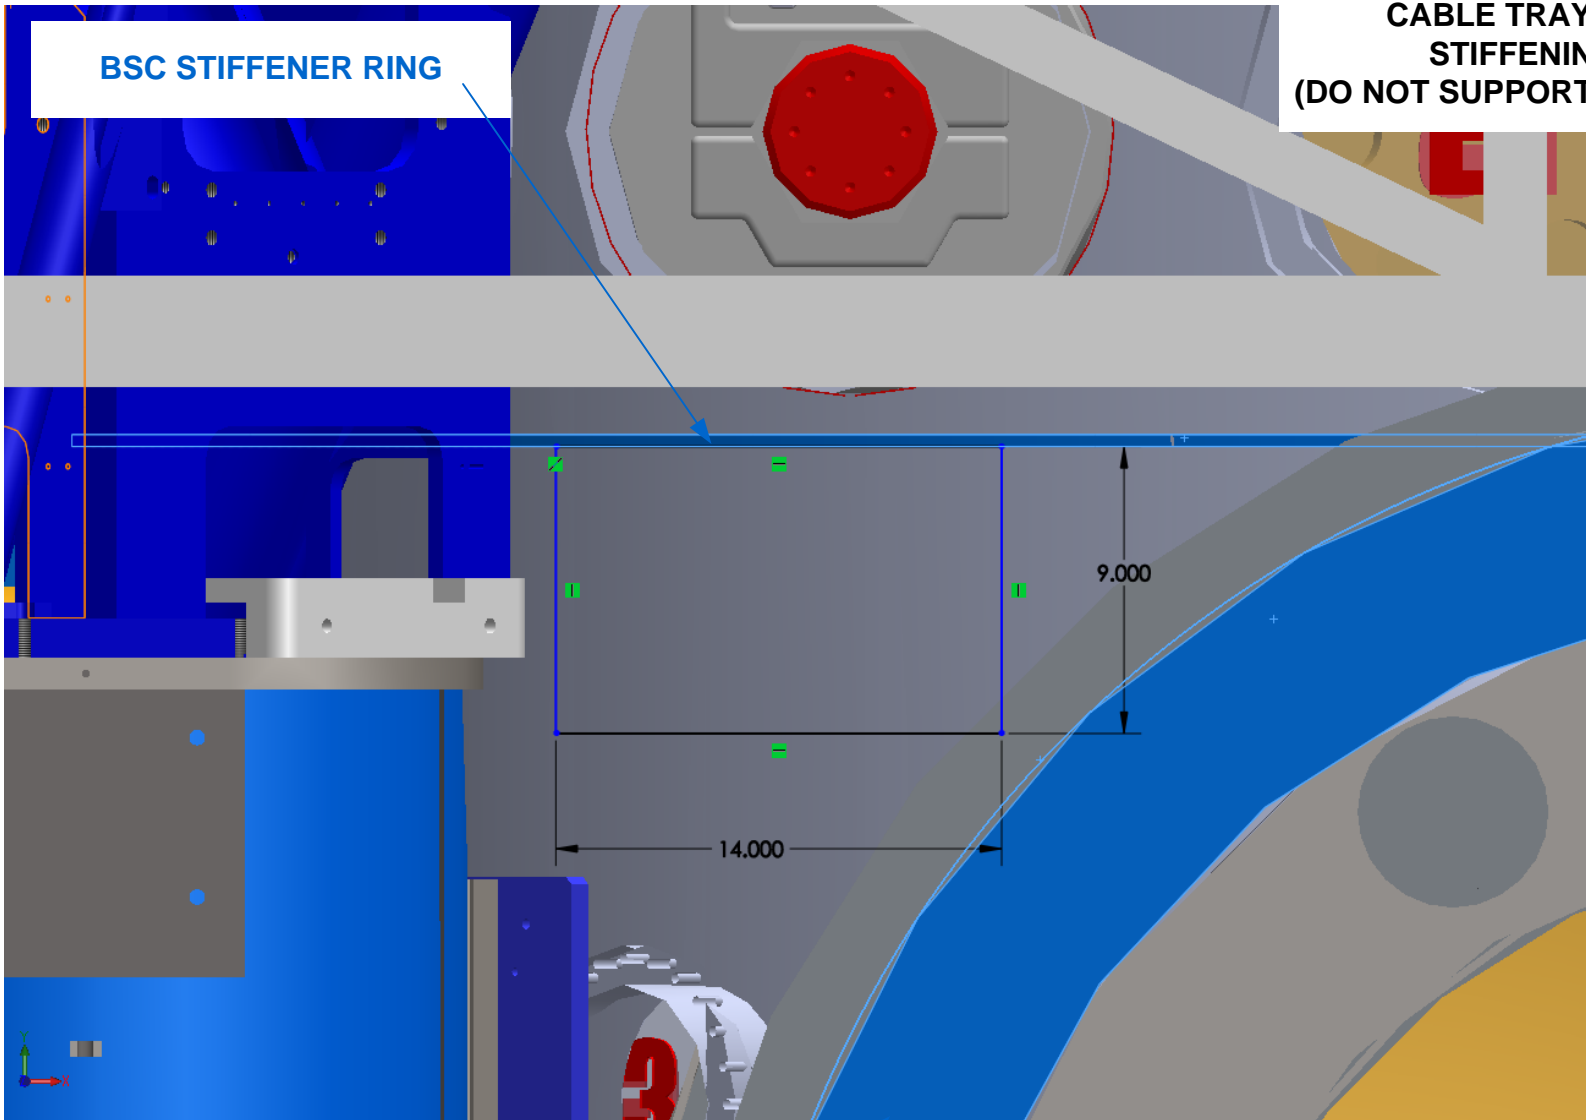
BSC-to-BSC TRAY LOCATIONS (14" X 9" FITS)

**SUPPORT BSC-TO-BSC
CABLE TRAY FROM BSC
STIFFENING RINGS
(DO NOT SUPPORT FROM THE PIER)**

**BSC-to-BSC CABLE
TRAY SPAN = ~67" OR 5.5 FT**
